IN ERLURY OUTBOARDS

NUMBER: 76-11 DATE : 5/14/70

1976 MERC 850 SPARK ADVANCE ARM SWIVEL REPLACEMENT

OFFICIAL NOTIFICATION Under the U.S. Federal Boat Safety Act

Figure 1. Adjusting Throttle Primary Pickup

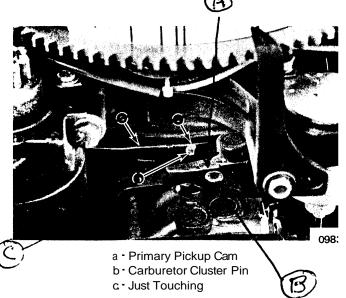
- b. With engine running in forward gear, move throttle lever until throttle primary pickup cam just touches primary pickup pin on carburetor cluster. (Figure 1) Without moving throttle lever, adjust primary pickup adjustment screw (Figure 2) to align throttle primary pickup specification with timing pointer. Tighten locknut.

Figure 3. Maximum Spark Advance Adjustment

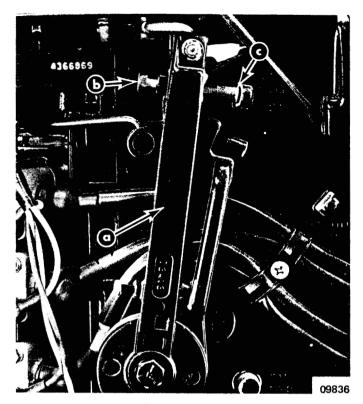
- c. Advance throttle lever to align maximum spark advance specification (on flywheel timing decal) with timing pointer and adjust maximum spark stop screw to just touch spark lever. (Figure 3) Tighten locknut and recheck maximum spark advance.

Figure 4. Throttle Stop Screw Adjustment

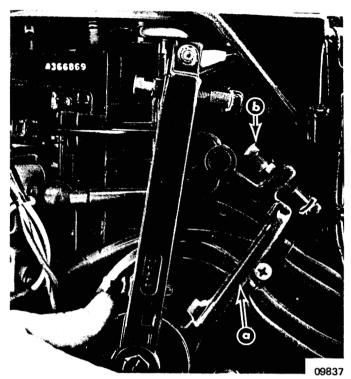
- d. Return engine to idle and stop engine. Remove Timing Light.
- e. With engine stopped, advance throttle lever to wide-open-throttle (**WOT**) position. Adjust throttle stop screw (Figure 4) to allow .010" to .015" (.254mm to .381mm) clearance between throttle cam and pin on carburetor cluster. (Figure 5)
